Site Accessibility Evaluation

**Path of Travel Bus Stop
Accessibility
PU18-0091**

**Galley Road / Peterson
Road
Cimarron Hills, CO 80915**

***Inspection Date: 09/13/2018
Inspector: David Mejia***

Finding: 1

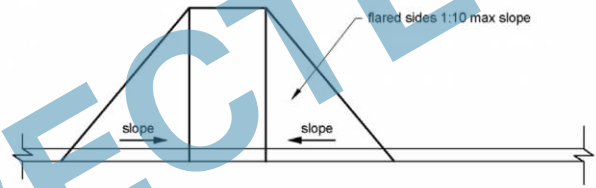
No diagonal or corner curb ramp exists.

2010 ADAS Section 406.3
Where provided, curb ramp flares shall not be steeper than 1:10.

Curb ramps non existant

Design and construct curb ramp for accessible path of travel. See 2010 ADAS section 4.06 for specificaitons and compliance. Maximum running slope of 1:12 (8.33%) and maximum cross slope of 1:48 (2.08%). if provided, curb ramp flares shall not be steeper that 1:10 (10%)

Corrective Action: Department of Public Works submitted and completed 2 compliant curb ramps along with 215 linear feet of 6 feet wide detachable sidewalk on 8/31/2018
